Date: Monday 18, Tuesday 19, Wednesday 20,
Thursday 21 and Friday 22 November 2024
Time: 9.30am
Meeting room: Council Chamber
Venue: Ground floor, Auckland Town Hall
301/317 Queen Street, Auckland

PRIVATE PLAN CHANGE 94
HEARING REPORT VOLUME 3
WAIRAKA PRECINCT IN CARRINGTON ROAD,
MT ALBERT
MINISTRY OF HOUSING AND URBAN
DEVELOPMENT – HANNAH MCGREGOR

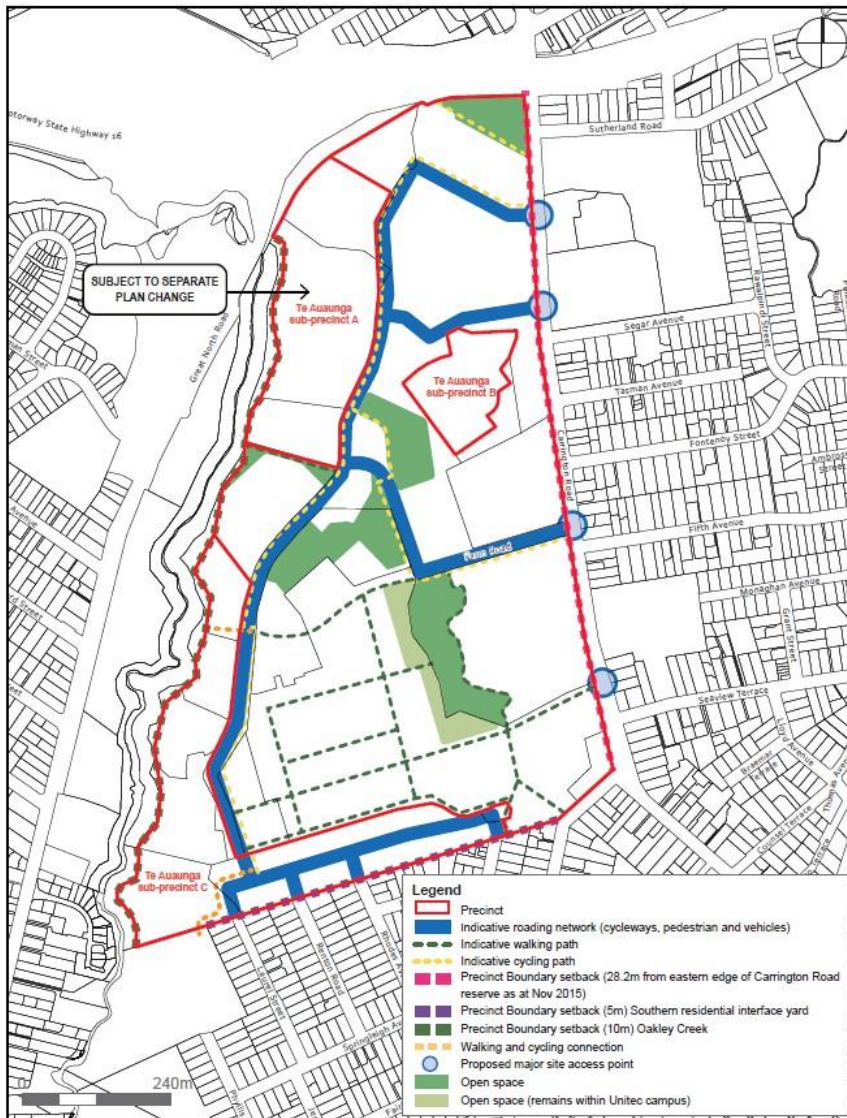
Commented [VW87]: Delete reference to only 'public' open space. This should be applicable to all 'open space areas'.

I334.10.2 Wairaka Te Auaunga: Precinct plan 2 – Protected Trees

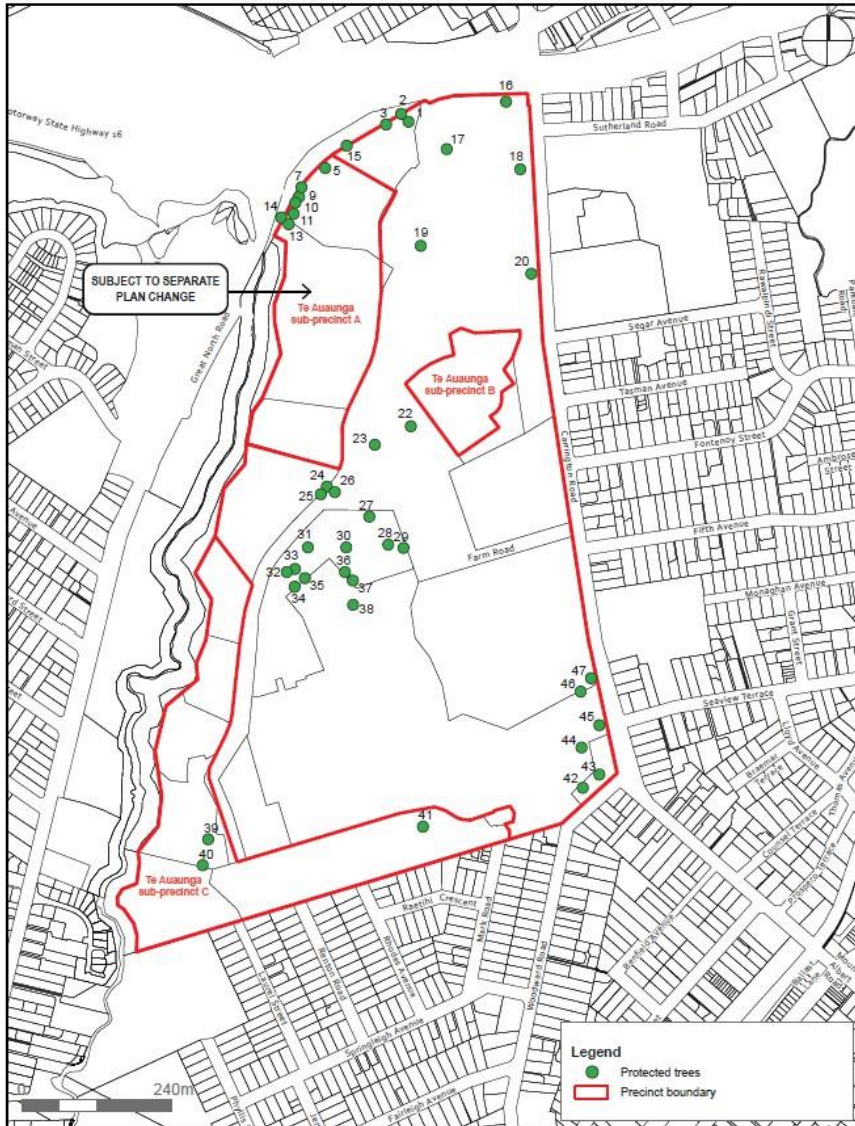
Commented [VW90]: Additional open space with a range of sizes and types should be provided in the Precinct to support development and population enabled in the Precinct. Open space should be identified on either Precinct Plan 1 or a new open space specific Precinct Plan. Details should reference that open space can be either publicly owned or privately owned but publicly accessible in perpetuity.

Commented [AE91]: The trees identified in the Precinct should be further assessed by an arborist against the notable tree criteria for scheduling in the Unitary Plan. Furthermore, all other trees remaining in the Precinct should be assessed for inclusion / identification and protection in the Precinct; and the list of trees identified in Table I334.6.7.1 – Identified Trees and on Precinct Plan 2 (I334.10.2) should be updated to those that remain post approved and implemented subdivision and infrastructure consents6.

I334.10.3 Te Auaunga: Precinct plan 3 – Te Auaunga Additional Height

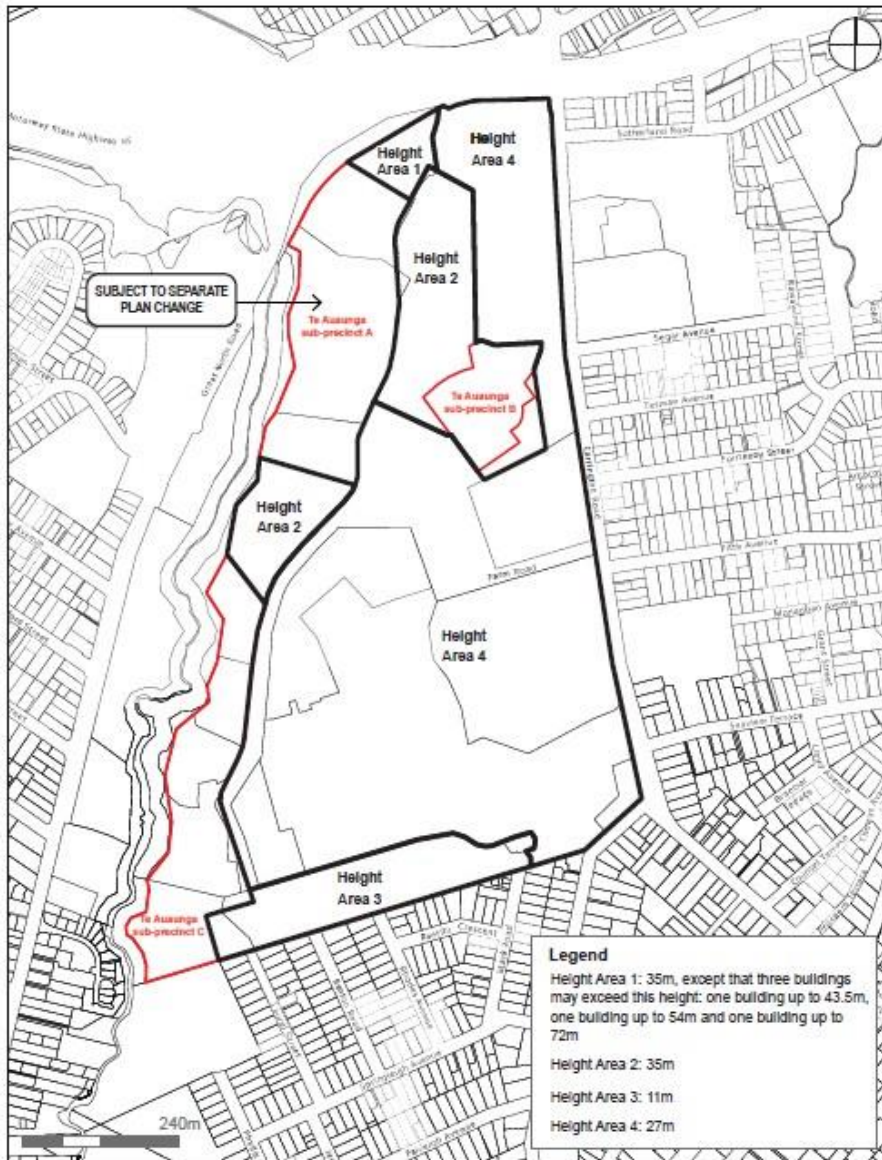
Commented [VW92]: This Precinct plan should be re-drawn to exclude identified open space areas from being within the additional height areas. If the spaces are identified for open space it is not appropriate to give them additional height. i.e remove northern open space from height areas 2 and 4.

Figure 2: Recommended Additions (in orange) To The Plan I334.10.2 Wairaka: Precinct Plan 2 - Protected Trees

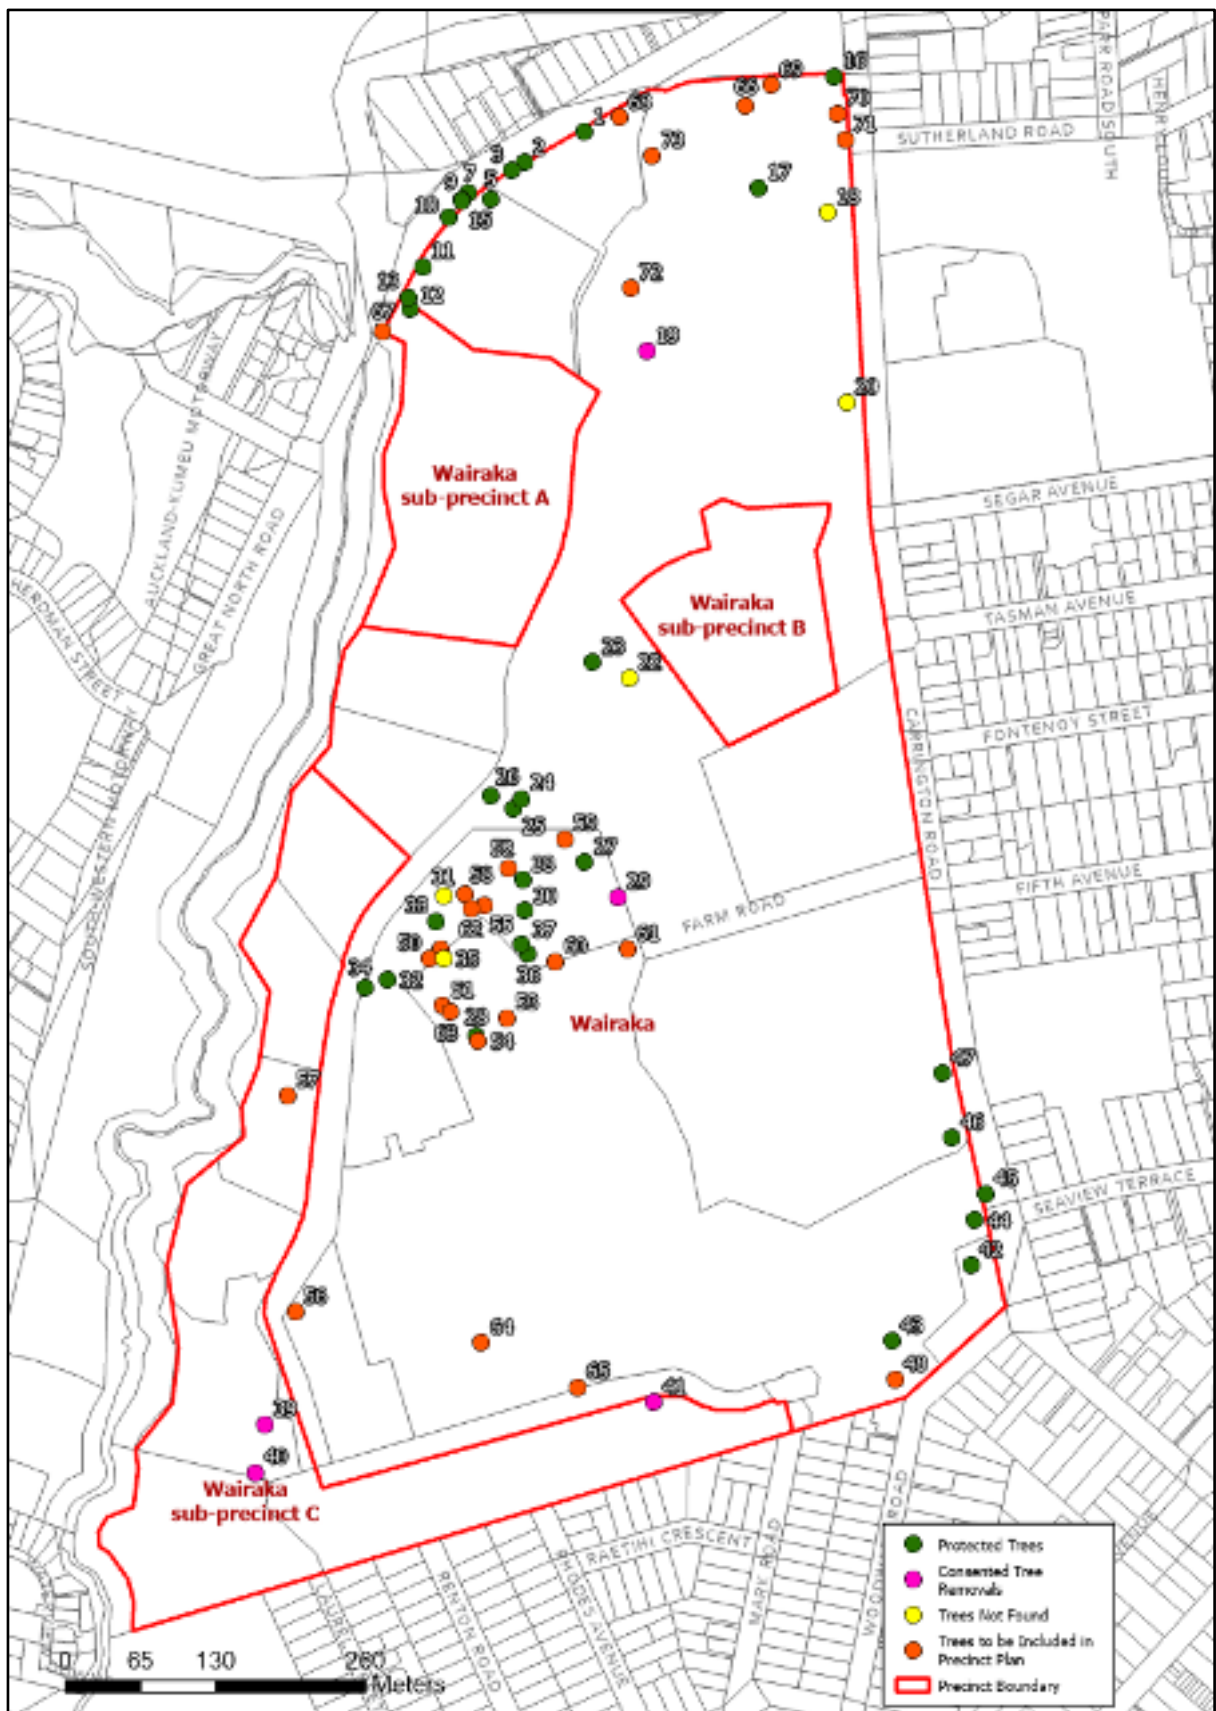
Conclusion

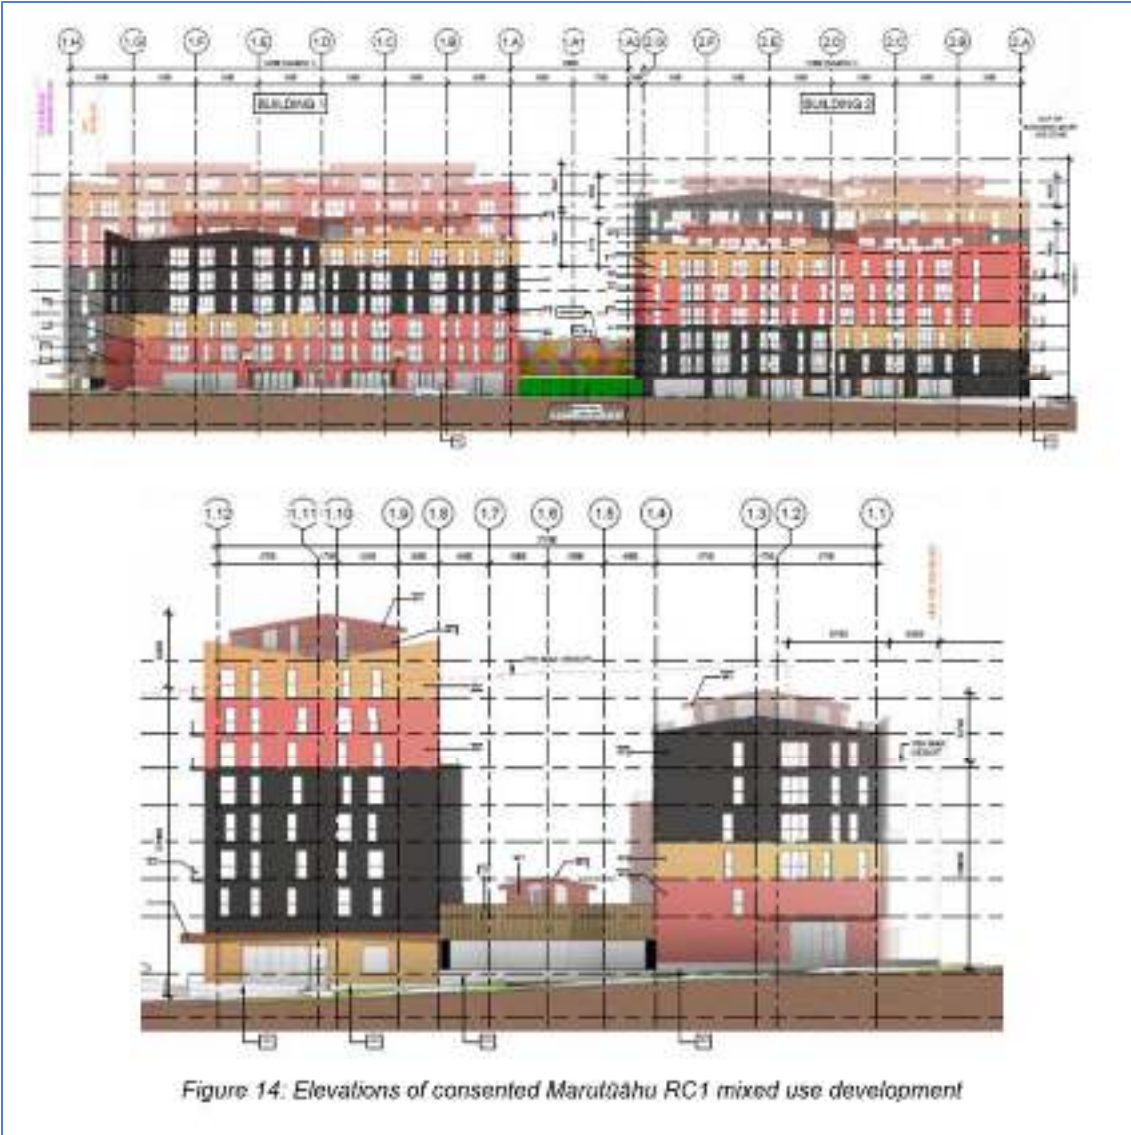
- I accept that the consented Marutūāhu RC1 buildings, with their step up from 5-6 storeys next to Carrington Road into 8-9 storeys away from the road corridor, represent an appropriate outcome

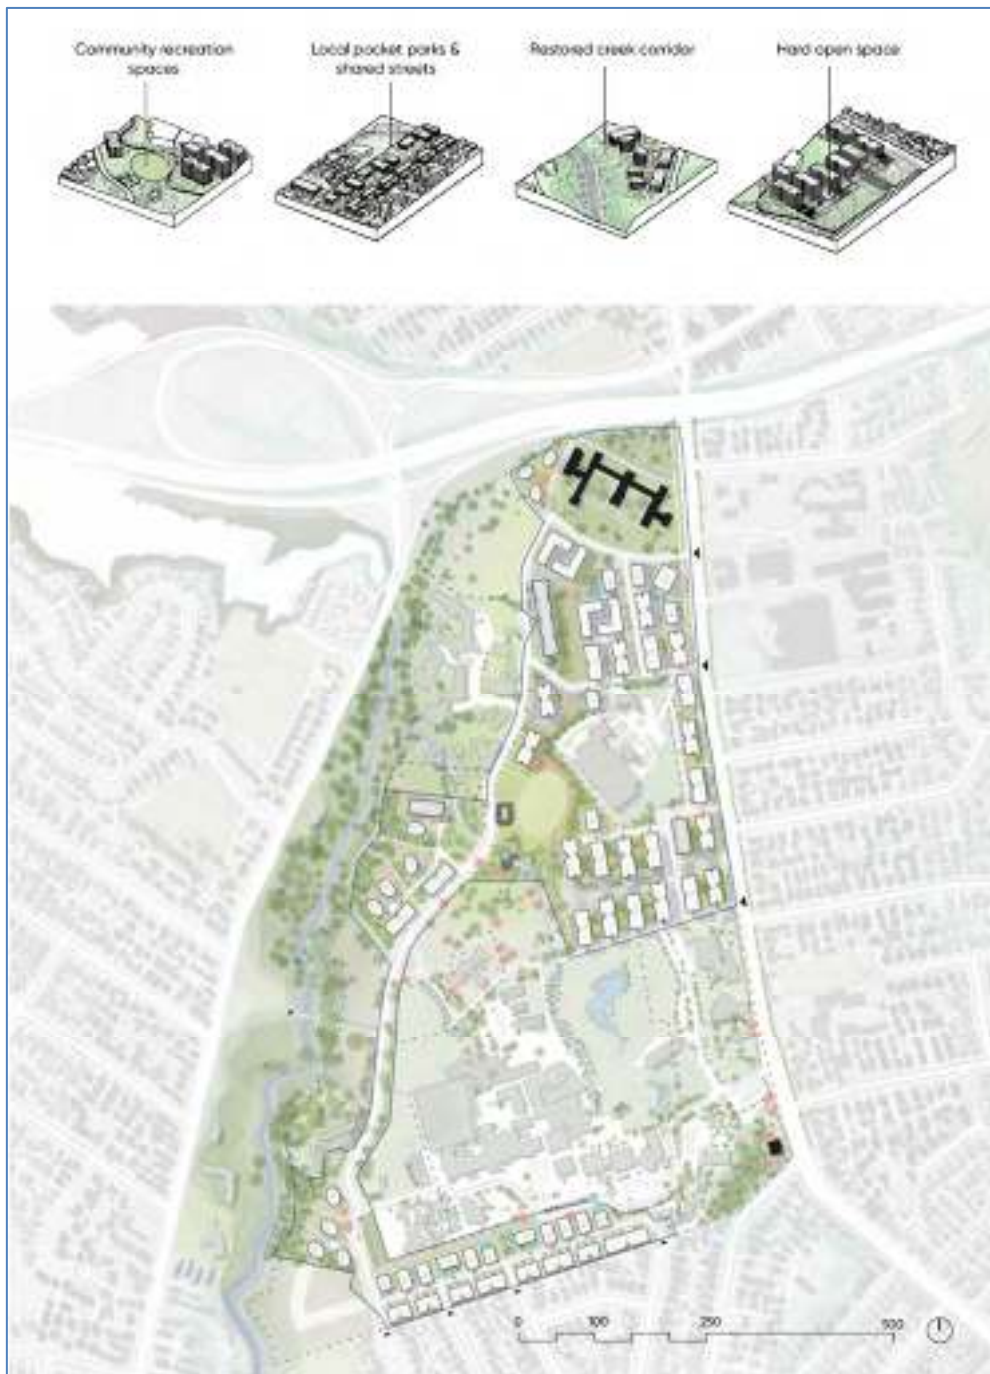
More positively, I accept that Precinct Plan 1 makes provision for formal linkages within the Precinct and beyond its boundaries, while – as the relevant Clause 23 response from BML explains – BUN60386270 (Centre/North), BUN60373075 (Wairaka Stream daylighting and pedestrian connection) and the Wairaka Precinct Stage 1 Project (South) establish the networks shown on that plan “*and anticipate the vesting of the majority of this network as public infrastructure, with a couple of minor exceptions such as the connection between the centre/north Spine Road and the south, which will be restricted to cyclists and pedestrians along the Waterview Shared Path. The Waterview Shared Path is not affected by the plan change.*”

In my opinion, these connections would be highly beneficial, both for occupants and users of the Precinct and those who use the streets, cycleways and pedestrian corridors connected to it.

Figure 2. Proposed open space requirement, source: I334.10.1 Te Auaunga: Precinct plan 1

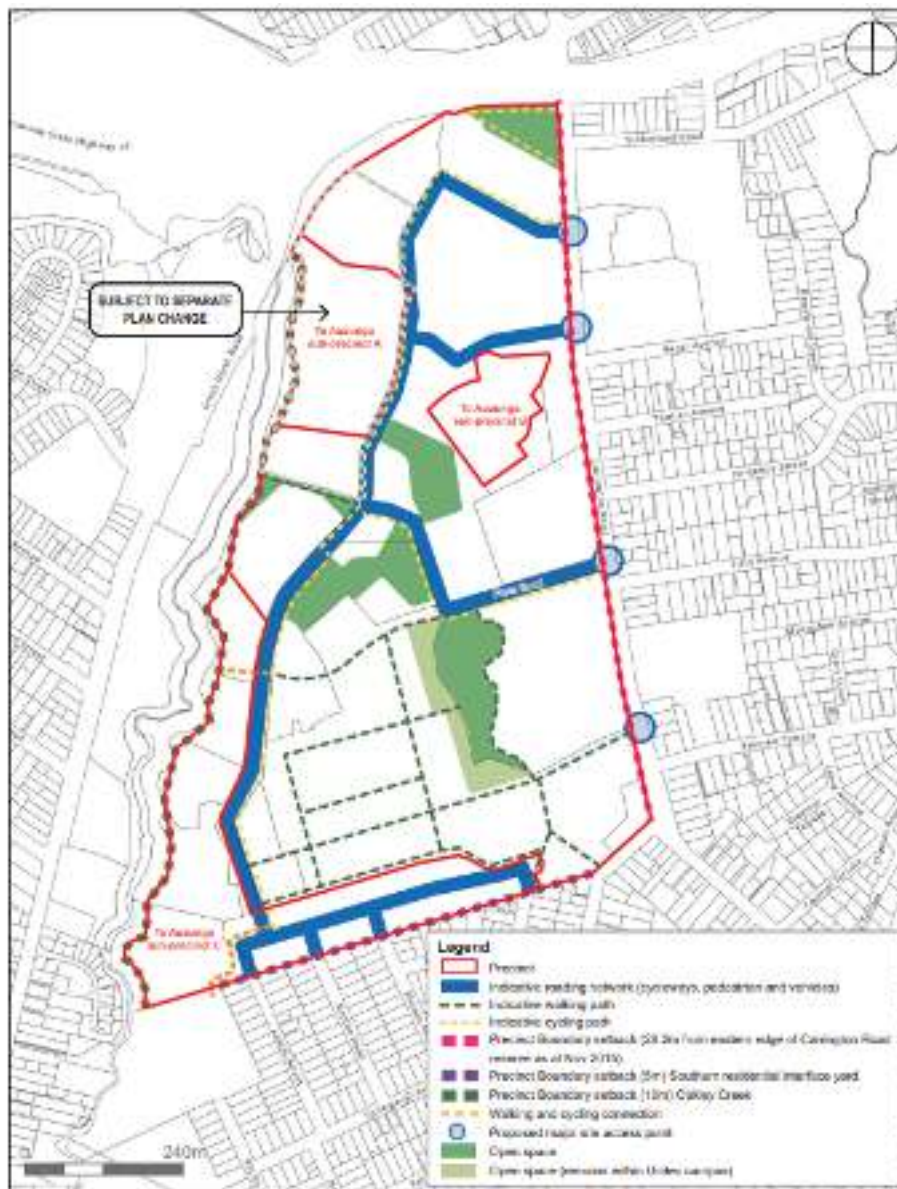
3.12 According to the figures provided in Mr. Greenaway’s report, the proposed open space would comprise approximately 4.6ha of open space which the Applicant sees as being public open space, subject to the Council agreeing to the acquisition of this land.

Figure 3. Snippet from Precinct Plan 1 + Open Space Accessibility provided in Attachment 05.1

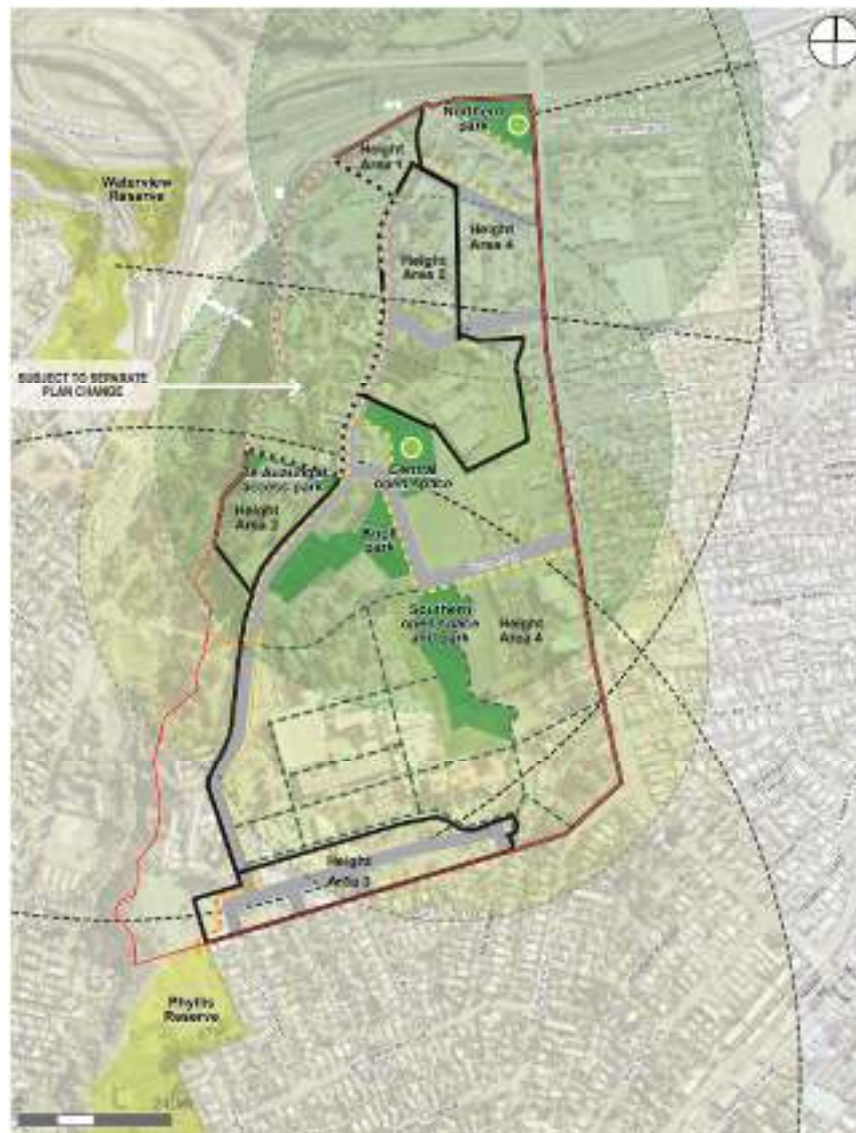
- 3.32 The Albert-Eden Greenways Plan also “*aims to improve walking, cycling and ecological connections*” across the local board area.
- 3.33 Attachment 05, provided in the Application documents for open space assessment refers to an “*extensive walkway and cycleway network*” to be provided “*between the open space areas and to/from the wider urban area*”. However, my assessment of the proposed open spaces within the precinct is that there is a gap between the Northern Park and Central open space proposed on the proposed precinct plan that is not proposed to be linked by any connections.

- 3.34 In a number of approved FT applications within the precinct, there is consideration of pedestrian linkages through the sites in order to provide pedestrian connections via a public access easement over privately owned lots.
